Office Action Summary

10/564,983

NAGATA, MASAKAZU

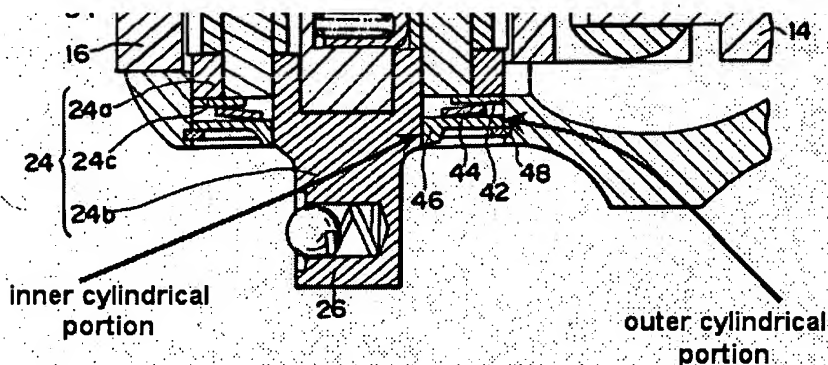
1. Figures 12-15 should be designated by a legend such as --Prior Art-- because only that which is old is illustrated. See MPEP § 608.02(g). Corrected drawings in compliance with 37 CFR 1.121(d) are required in reply to the Office action to avoid abandonment of the application. The replacement sheet(s) should be labeled "Replacement Sheet" in the page header (as per 37 CFR 1.84(c)) so as not to obstruct any portion of the drawing figures. If the changes are not accepted by the examiner, the applicant will be notified and informed of any required corrective action in the next Office action. The objection to the drawings will not be held in abeyance.
2. Claims 1-21 are rejected under 35 U.S.C. 112, second paragraph, as being indefinite for failing to particularly point out and distinctly claim the subject matter which applicant regards as the invention.

4. Claims 1, 6, 8, 10-12, 16, 18 and 20-21 are rejected under 35 U.S.C. 102(b) as being clearly anticipated by the admitted prior art of Figure 12 of the instant invention.

Figure 12 of the instant invention discloses a spring "44", a guide member "46" protecting the spring, hold means "46, 48", drop-out preventing means or snap-ring "48". The guide member has inner and outer cylindrical portions and the spring is accommodated in the space between the portions.

Figure 12 of the instant invention discloses all of the claimed subject matter except for having an abrasion preventing member obstructing contact between the shank the annular hold portion, the member having an annular shape with a hole through which a shank projection is fitted. Kusama discloses an abrasion preventing member "32 and/or 71" obstructing contact between the shank the annular hold portion, the member having an annular shape with a hole through which a shank projection is fitted. It would have been obvious to one having ordinary skill in the art to form the device of Figure 12 of the instant invention with an abrasion preventing member obstructing contact between the shank the annular hold portion, the member having an annular shape with a hole through which a shank projection is fitted to prevent abrasion as taught by Kusama.

Figure 12 of the instant invention discloses all of the claimed subject matter except for having an abrasion preventing member obstructing contact between the shank the annular hold portion, the member having an annular shape with a hole through which a shank projection is fitted and the member having a rotation preventing means. Horvath discloses an abrasion preventing member "246" obstructing contact

Figure 12 of the instant invention discloses all of the claimed subject matter except for the housing be heat treated. Bosque discloses a tool housing being heat treated. It would have been obvious to one having ordinary skill in the art to form the housing of Figure 12 of the instant invention as heat treated for added strength as taught by Bosque.
